Design Review Subcommittee (DRSC)

Meeting Date: November 14, 2018

SUBJECT: Site Plan Permit 17-400, Architectural Permit 17-403, Conditional Use Permit 17-404, Tentative Parcel Map 17-405 and Discretionary Sign Permit 18-215 - Target Site Commercial Retail Center, a request to subdivide the Target property into two parcels and to construct a multi-tenant commercial retail center with a drive-thru restaurant at 990 West Avenida Vista Hermosa in the Forster Ranch Specific Plan area.

Design Review Subcommittee (DRSC)

Exhibit 4 Pedestrian Walkway

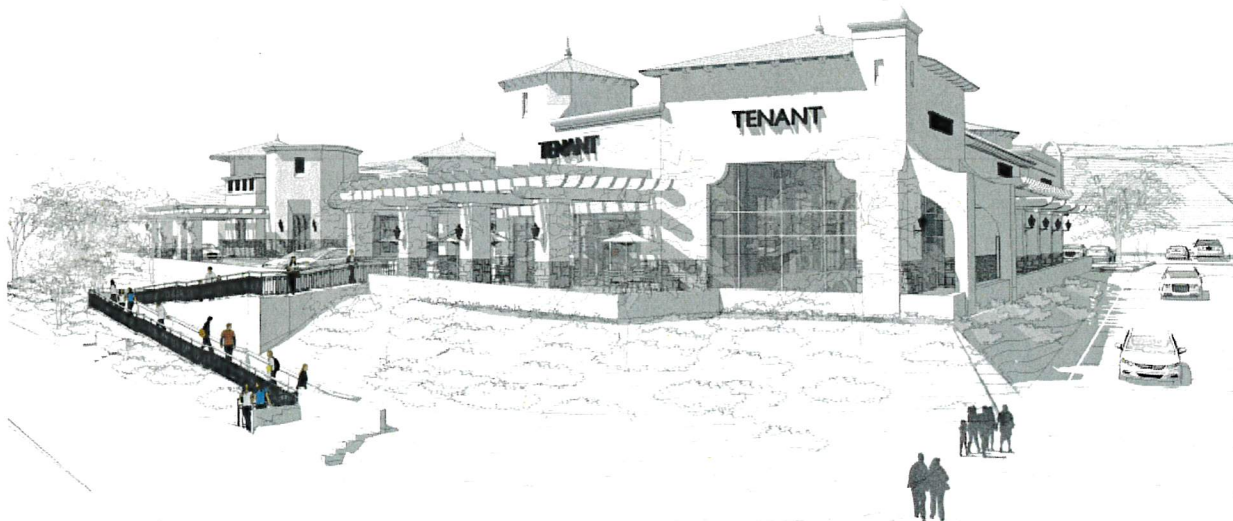
The applicant has incorporated a new walkway into the project proposal in response to the request from the DRSC and in compliance with ADA accessibility. This walkway will provide pedestrian access directly from Avenida Vista Hermosa to the project site. Reference Attachment 4, Perspective Views for additional renderings.

Exhibit 2, Represents Sign Types 1, 1a (Target only), 3, and 4

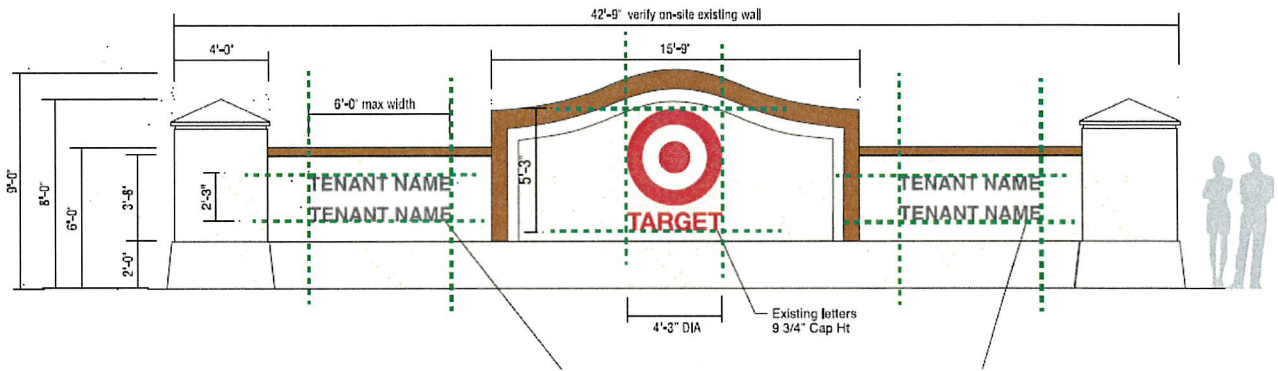
The proposed wall signage and copy with tenant names proposed on the existing monument signs complies with sign area requirements, subject to the approval of a DSP. While the proposed new Sign Type 3 and 4 monument signs exceed the maximum size of signs, they are the same as those existing at the entry and appear to be in scale and proportional to the project site. Additionally, a required finding for a DSP, pertaining to freestanding signs, is: "If a freestanding sign is included in the sign application, the design, scale or location of the building dictates the use of freestanding signs, rather than building-mounted signs."

The monument signs are not anticipated to appear inconsistent with the design of the buildings because Sign Types 3 and 4 are located at a distance and below the grade of the buildings. Instead, these monument signs will provide signage for businesses located on the project site where there is limited visibility.

Staff requests input from the DRSC on whether the proposed monument signs, including Sign Types 3 and 4, are warranted based on the design, scale or location of the building. Staff recommends that Sign Type 2 (new monument) and Type 6 (menu boards) be reduced in size to meet the City’s sign code requirements.

Sign Type 2 - NEW Project Monument Sign - With Tenant Names
Scale: 1/4"=1'-0"

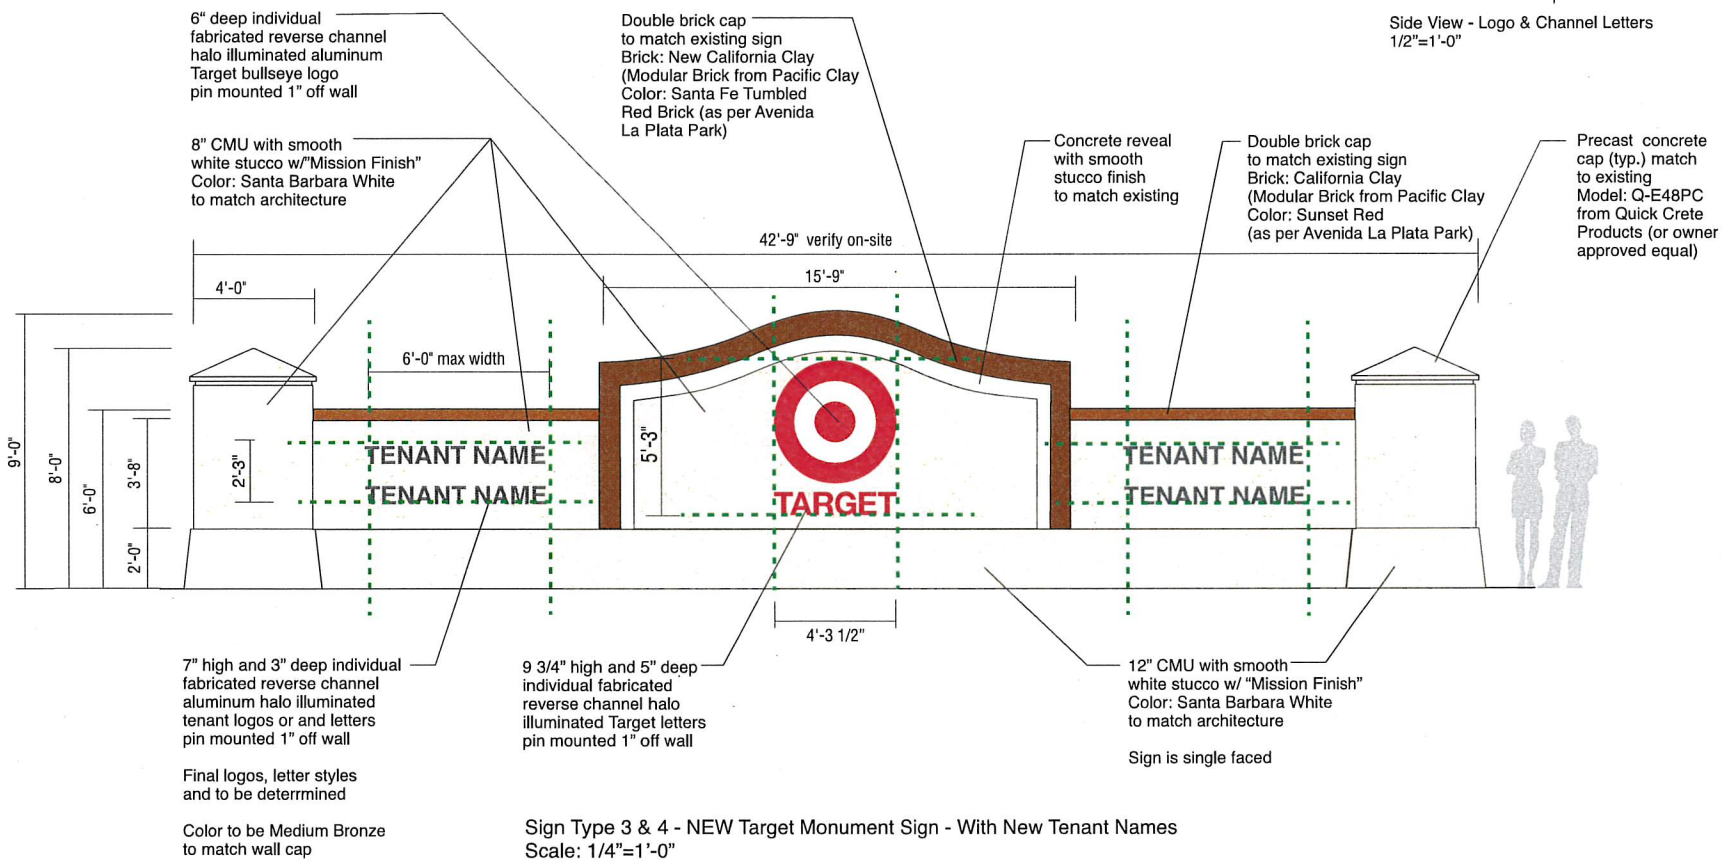
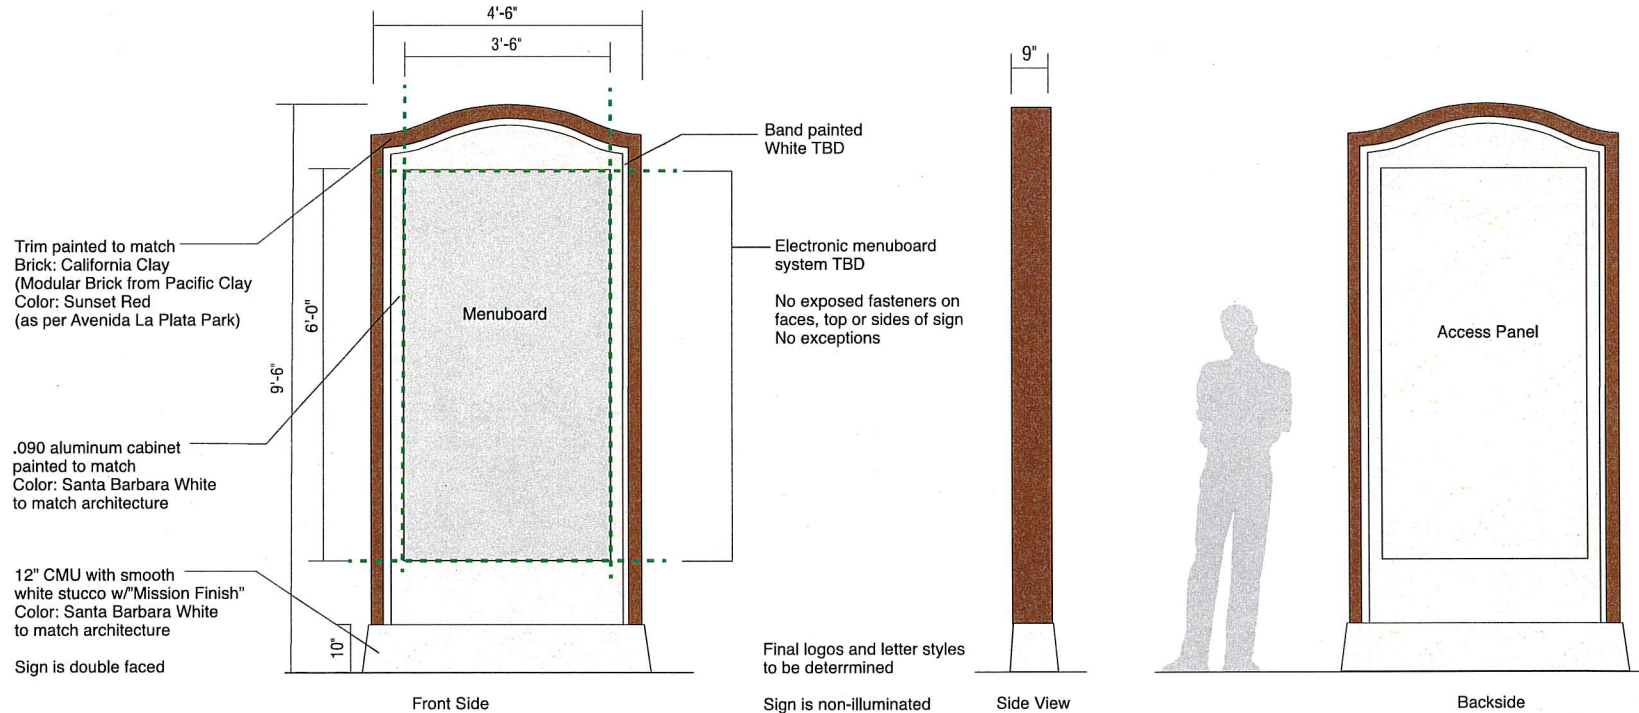
10. Revise the proposed Master Sign Program to include monument signs not exceeding 64 square feet in area. Staff is also interested in the specifications for the drive-up menu board sign.
